**Symptom - Body Exterior - Reversing Camera/Reversing Camera Spray Nozzle Does Not Function: Checking Rear Wire Harness (SY 131/20)**

Model Line: **Taycan (Y1A)**

Model Year: **2020**

Subject: **Reversing camera/reversing camera spray nozzle**

*Hose line for reversing camera spray nozzle*

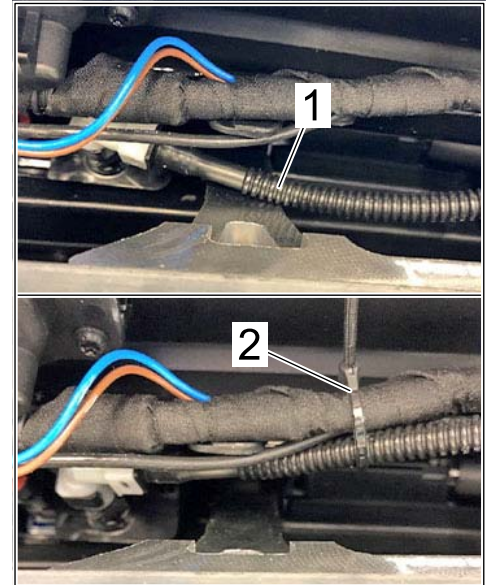
Cause: The wire harness or hose line for the reversing camera spray nozzle may be touching the vehicle bodyshell and can become damaged over the service life of the vehicle.

- Work Procedure: 1 Check rear wire harness and hose line for reversing camera spray nozzle ⇒ *Hose line for reversing camera spray nozzle -1-* for damage and replace them if necessary, see ⇒ *Workshop Manual '972519 Removing and installing rear wire harness'*.
- 2 Secure hose line for reversing camera spray nozzle ⇒ *Hose line for reversing camera spray nozzle -1-* to the rear wire harness with a tie-wrap ⇒ *Hose line for reversing camera spray nozzle -2-* as shown.

Remedial Action: In the event of a customer complaint, check the wire harness and replace it if necessary. Also secure the hose line to the wire harness using a tie-wrap.
